**CHARTER TOWNSHIP OF VAN BUREN
PLANNING COMMISSION
MAY 10, 2017
MINUTES**

ITEM # 1 17-007 – PRELIMINARY SITE PLAN APPROVAL

**Subject: VBT-17-007 SPR; Continental Canteen at 7850 Haggerty Road; Site Plan Review #2;
Revised Plans Dated April 20, 2017**

Aerial Image of Site (Source: Wayne County GIS 2017)

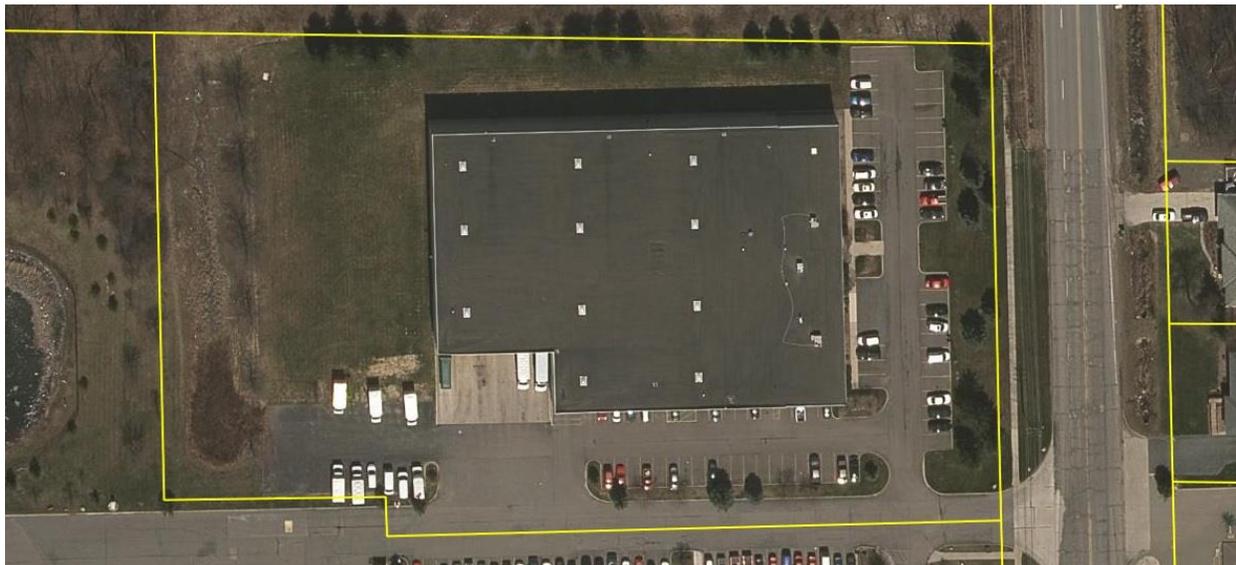
- 1. Zoning and Use.** The site is zoned M-1 (Light Industrial) zoning district. The surrounding zoning includes an M-1 site to the south and west, C-1 (General Business) to the north, and AG (Agricultural and Estates) to the east across Haggerty Road.
